KC Apparels Ltd

Plot # B 424, 425, 426 & 427. Road # 1, BSCIC Industrial Estate,
Shashongaon, Anayetnagar, Fatullah, Narayanganj -1420
(23.6245865, 90.4807325)

2 June 2024

1. Building Information

Observation 1: Inconsistencies in design documents.

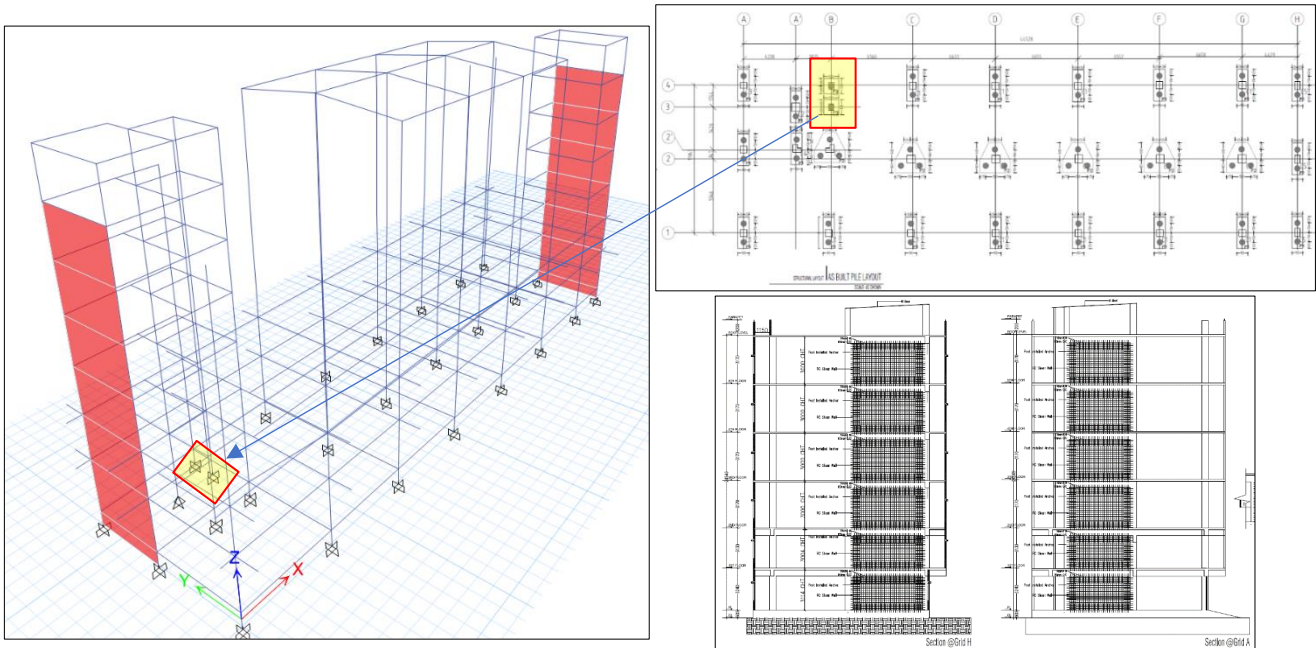
Description: The building engineer assessed the structure and proposed the shear wall to resist lateral loading. As per the proposal, the shear wall was constructed between November 2021 to May 2023.

The foundation details for the shear wall have not been provided in the as-built drawing. In the FEA model, the shear wall has been assigned below the grade beam.

So, the factory is required to provide the foundation details in the drawing and check the adequacy of the foundation considering vertical loading as well as lateral loading.

In the FEA model, two foundations have been considered fixed support which consists of a single pile (marked in figure). The building engineer is required to provide clarification in the report to support the consideration.

The building consists of a beam-column moment frame up to the 2nd floor and a flat plate from the 3rd floor to the roof. The shear wall has been constructed from bottom to top. The structural system and load-bearing mechanism for the lateral load need to be confirmed by the building engineer.

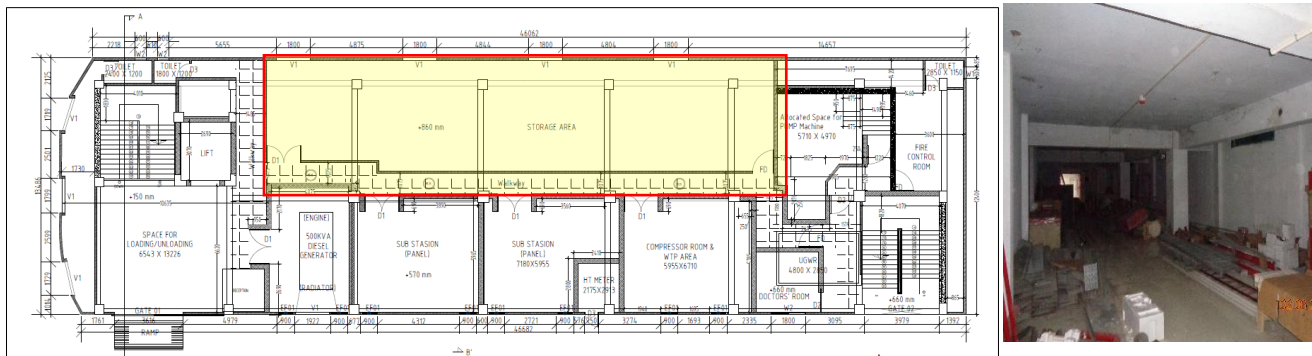
Description: Two concrete cores have been taken from the flat plate 3rd floor and 5th floor. The equivalent concrete strength of flat plate has been calculated considering the cores from the flat plate and cores taken from the beam & slab.

The equivalent concrete strength for the flat plate needs to be calculated separately by taking at least four cores from the flat plate.

Also, some of the cores could not be verified during the inspection as per the core layout plan.

Ground floor layout plan. Suspend slab over the UGWT in the marked location

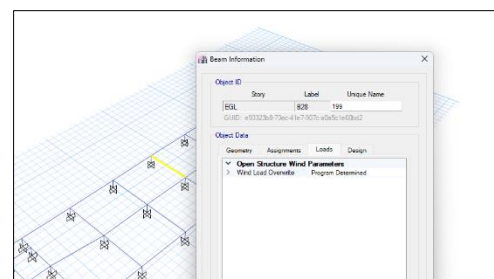
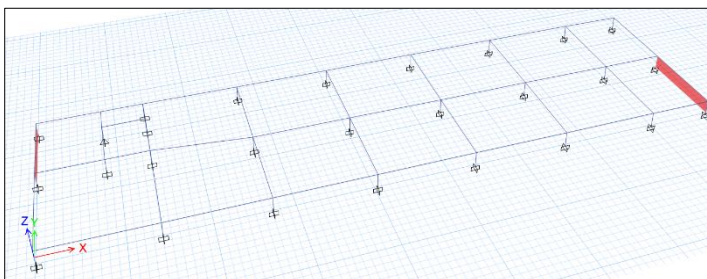
Description There is an underground water reservoir. The underground water reservoir's roof slab (Ground floor slab) is being used as storage. Loading has not been considered for the FEA model for the beam & slab. Also, load plan has not been prepared for the suspended slab ground floor as well as for the stair top & shed top.

The building is required to prepare a load plan as per BNBC and check the adequacy of the beam and slab.
